Oregon Water Resources Department

REQUEST FOR WRITTEN APPROVAL TO USE CONSTRUCTION METHODS NOT INCLUDED IN OREGON ADMINISTRATIVE RULES 690-200 THROUGH 690-240

Address at well site: Skyliners Rd. Bend, Or.

WATER RESOURCES DEPARTMENT WELL INSPECTION FORM

- (7) Diagram showing the pertinent features of the proposed well design and construction (attach additional pages if needed):

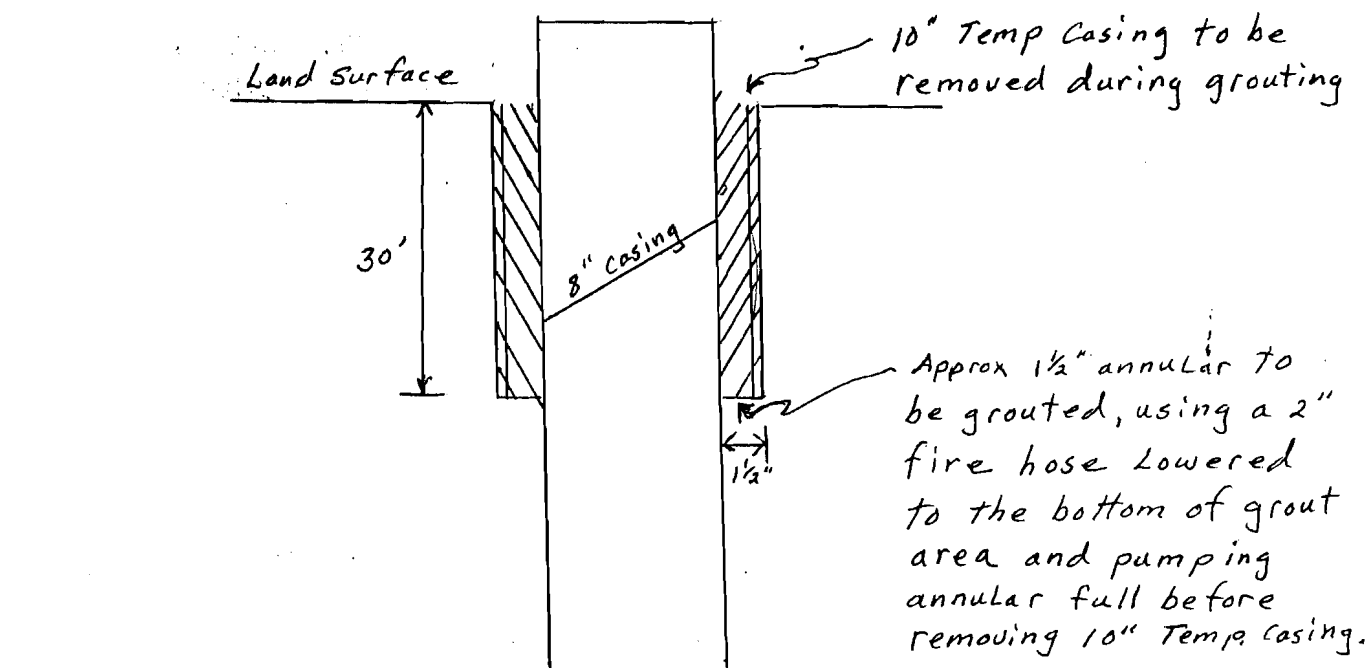
(5) The unusual conditions which necessitate this request: Drilling with (ODEX)

System. Drilling 10" hole for seal area, and

Taking 10" casing down to hold annular open. 8" casing for finished hole and surface casing.

Pressure grout from -30' to L.S., between the 8" and 10" casing and removing 10" temp. casing during

grouting process. (ODEX) Drills approx. 11 1/2" hole with a 10" bit. Grout will be placed by using a 2" Fire
hose between the 8" & 10" casing

Remarks: Per. Phone conversation with Rob Carter

Remarks Note: While I was observing the surface seal grouting using a fire hose between the 8" and the 10" Temp. casing, I felt this procedure went very well and the 30' annular took 1 1/2 yards of cement grout and the 10" Temp. casing was removed with no problems.
